SAFETY BULLETIN

Number 004/2017

Product	HI-FOG 1900 Sprinklers installed in A1000 type Assembly Bodies: C-0001318 C-0006553 C40022 C40022.1 C40024 C41041.1 C41041.2 C41042 C41045		
Subject	HI-FOG 1900 may not be compatible with some of the A1000 Assembly Bodies equipped with internal stop valve.		
Summary	The internal stop valve of A1000 Assembly Bodies of the types listed above may be pushed beyond its intended range when a HI-FOG 1900 sprinkler is installed.		
Date	18 th September 2017	Rev.	A

**HI-FOG® 1900 SPRINKLER
WITH
A1000 TYPE ASSEMBLY BODY WITH STOP VALVE
IDENTIFICATION AND CORRECTION PROCEDURE**

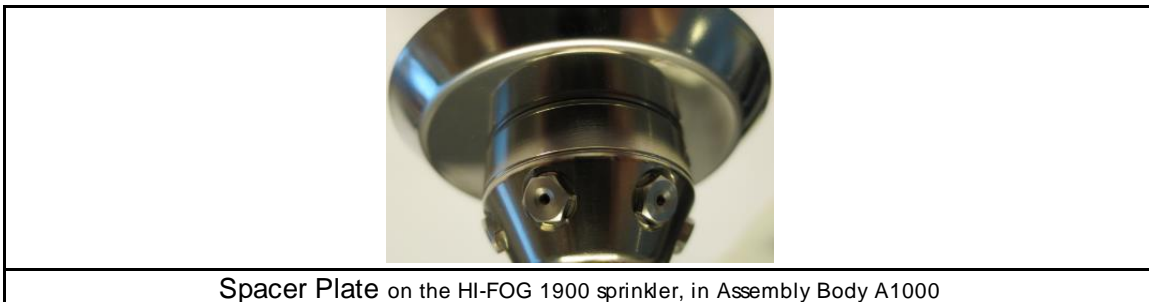
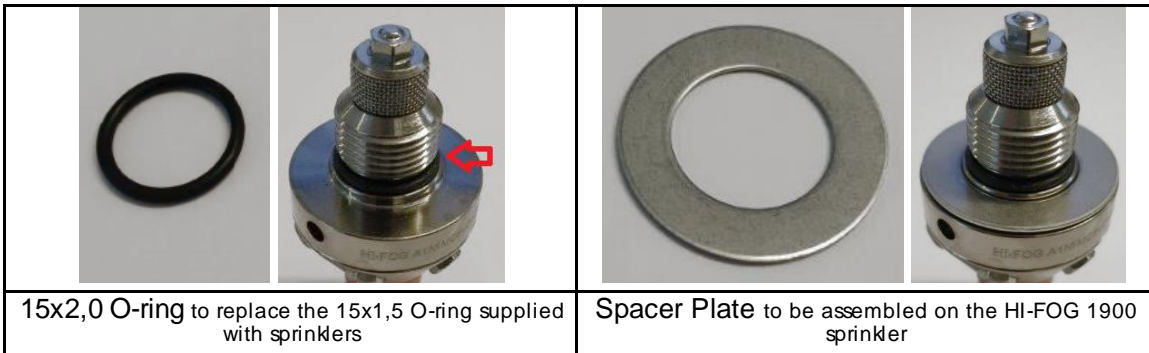
The A1000 Assembly Bodies were built to accommodate the HI-FOG 1000 sprinklers. Some models of this Assembly Body include an internal stop valve that prevents the flow through the Assembly Body if the sprinkler is removed. For these Assembly Body models listed, there is a risk that HI-FOG 1900 sprinkler will press the stop valve beyond the intended range and thus may diminish or in the worst case prevent the water flow to the sprinkler in case of a discharge.

The risk does not extend to Assembly Body types A2000, AB and C, to Assembly Bodies without an internal stop valve or to any other HI-FOG sprinklers with any Assembly Body. See illustration below for identification of affected components.

To assure compatibility of HI-FOG 1900 sprinklers with all Assembly Body types, each HI-FOG 1900 sprinkler installed in an affected A1000 type Assembly Body should have the 15x1,5 O-ring replaced with a 15x2,0 O-ring and a Spacer Plate (Marioff Item Code 2000267114) should be installed between the sprinkler and the Assembly Body cover plate. If there is no cover plate, the spacer is to be installed between the sprinkler and the Assembly Body. Follow Marioff instructions (Document number 0003301084) when carrying out the field action.

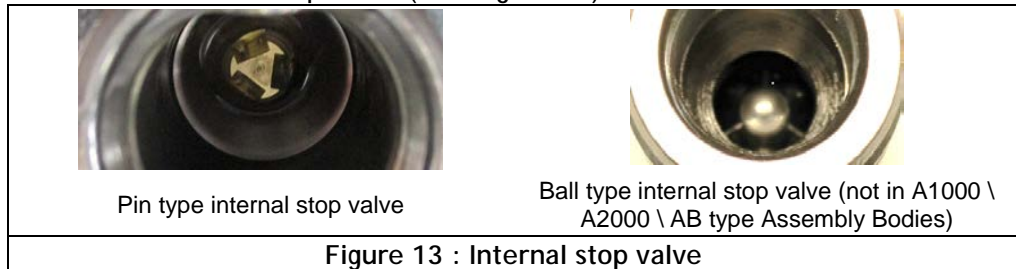
If the type is A1000 then verify from the inside of the assembly body if there is an internal stop valve (see Figure 13).

If there is **NO** internal stop valve, reinstall the sprinkler (go to step **g** below).
If the type is A1000 AND there IS an internal stop valve then continue:

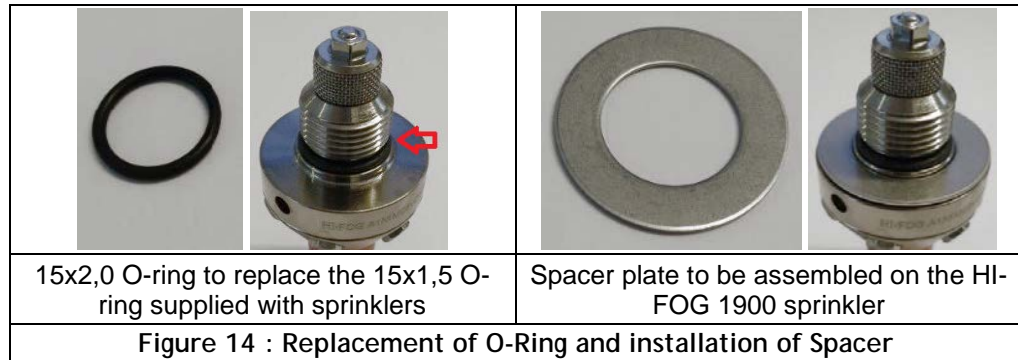
- e. Remove the 15x1,5 O-ring from the sprinkler (see Figure 14). Do not damage or scratch the sprinkler's sealing surface. Cut the removed O-Ring to assure it does not mix with the new seals.

- f. Install the new 15x2,0 O-ring to the sprinkler by placing the O-ring installation cone (see Figure 05) over the spindle and rolling the new O-ring onto the sprinkler until you are sure the O-ring sits correctly in its groove (see Figure 14).
- g. Install the spacer to the sprinkler (see Figure 14).
